# Staff Report

**RE:** **Level 2 Unified Permit – 112 Barnum Road Unified Permit Application**

Regarding: Response to Comments  
Level II Unified Permit Application  
112 Barnum Road  
Devens, MA

DRAWING NUMBER: **C-2**

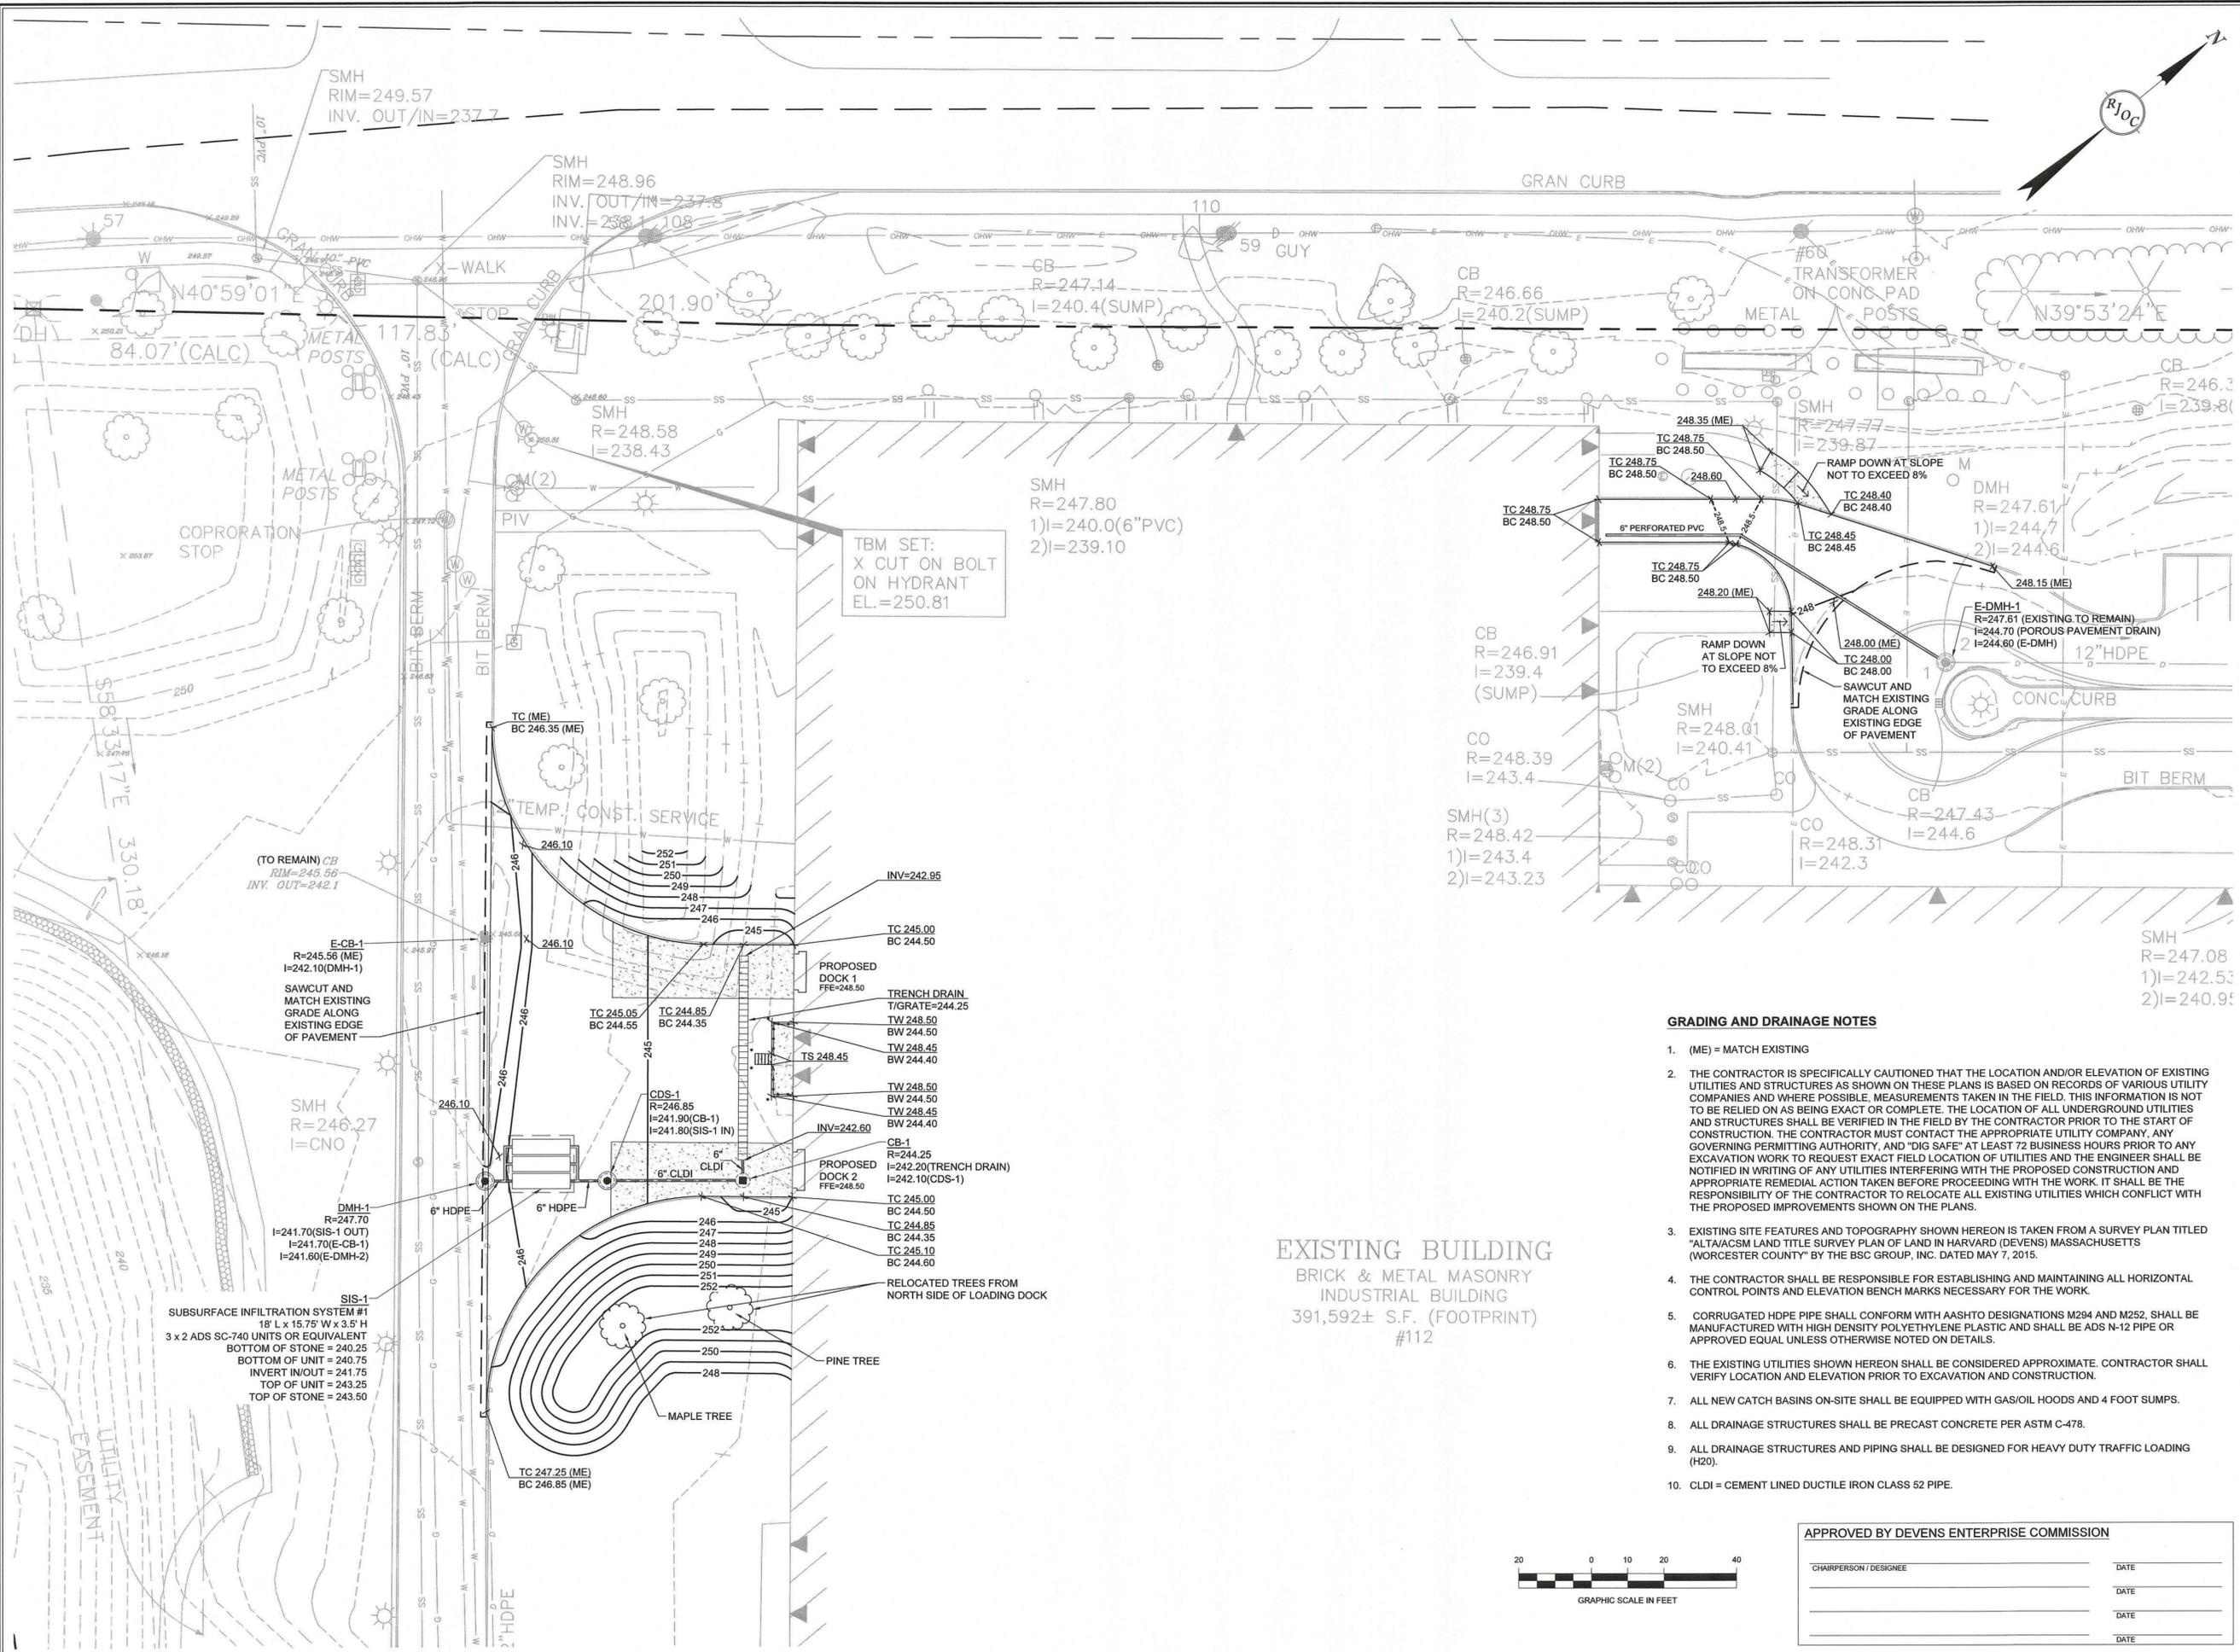
7. *On sheet C-2 it appears the top of stone elevations for Subsurface Infiltration System #1 was incorrectly labeled. The stone depth on the of the chambers should be 6 inches, not 3 inches, per the Stormtech Detail. The Applicant should review and address this requirement and confirm that adequate cover will be provided over the chambers.*

8. *The areas of porous pavement closest to the roll up door is flat at elevation 248.5. This may become an issue if the porous pavement becomes clogged and water pools against the building. We recommend that the Applicant evaluate the potential to pitch the driveway away from the building at less than 5 percent.*

9. *The porous pavement underdrain is modeled as 4 inches in HydroCAD but is shown as 6 inches in the plan and detail. The Applicant should review this for consistency.*

- a. *The porous pavement section is intended to provide groundwater recharge for the roll up door driveway. To meet this requirement, the underdrain in the porous pavement section should be raised above the groundwater recharge volume.*

- b. *The proposed subsurface infiltration system is providing both water quality treatment and groundwater recharge for the loading dock, therefore it must be sized to hold the total water quality volume and provide the required recharge volume below the outlet. Based on the HydroCAD the total system volume does not meet the water quality volume and the volume below the outlet does not meet the storage volume. The Applicant should review and address this requirement.*

**Response:** That is correct and will be fixed on the final plan set.

**Response:** The final plan set will include a pitch away from the building.

**Response:** The 4" size is correct and will be labelled correctly on the final plans.

**Response:** The underdrain will be raised up and shown correctly on the final plan set.

**Response:** The subsurface infiltration system has been increased in size to provide the required storage volume and will be shown on the final plan set. See Attachment 2 for volume calculations for the infiltration system and porous pavement.
